**GOVERNMENT OF THE DISTRICT OF COLUMBIA
DEPARTMENT OF TRANSPORTATION**

MEMORANDUM

SUBJECT: ZC Case No. 15-29 – Shepherd Park PUD (7828 Georgia Avenue NW)

The District Department of Transportation (DDOT) review responds to the revised Comprehensive Transportation Review (CTR), dated May 31, 2016.

Figure 1 Site Design and Access (Source: Perkins Eastman)

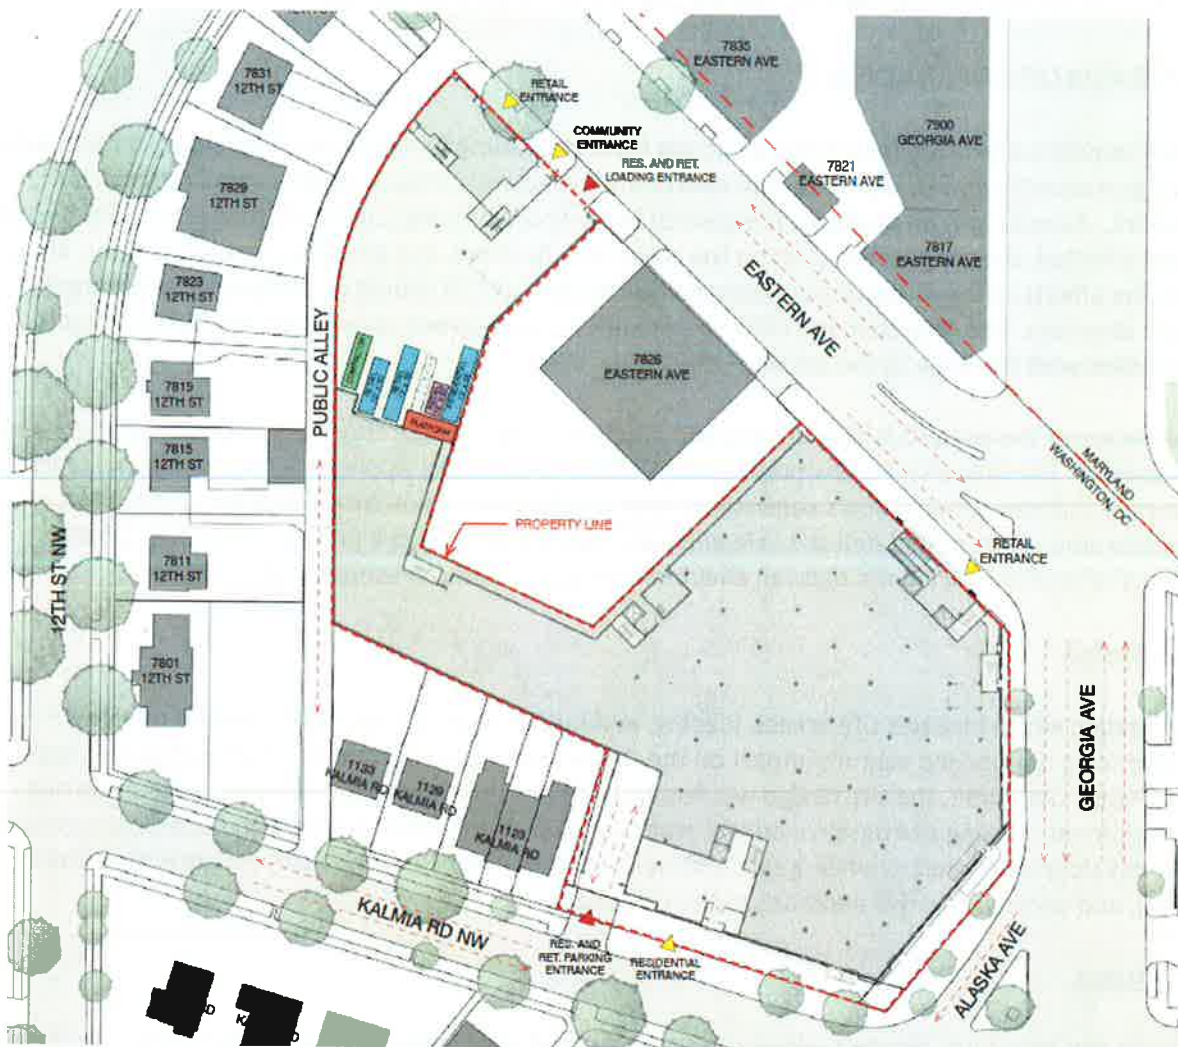
Vehicle and long-term bicycle parking access is proposed via a single curb cut on Kalmia Road that serves the parking for both the retail and residential uses. Of note, the Applicant proposes a sign within the garage to restrict right turns out of the garage onto westbound Kalmia Road. As discussed in the Travel

Assumptions section, DDOT does not support turn restrictions out of the site due to Kalmia Road's functional classification as a Collector and the likelihood of further impacts to the Georgia Avenue/Alaska Avenue/Kalmia Road intersection if implemented.

Loading and trash access is proposed via a single curb cut on Eastern Avenue.

Primary pedestrian access points are proposed on Eastern Avenue and Kalmia Road for the retail and residential uses, respectively.

Truck-turning diagrams provided by the Applicant demonstrate that all truck maneuvers can be accommodated with head-in, head-out movements consistent with DDOT standards.

- Ensure full access out of the parking garage driveway on Kalmia Road, which is consistent with the analysis. DDOT has not seen analysis of limited access;
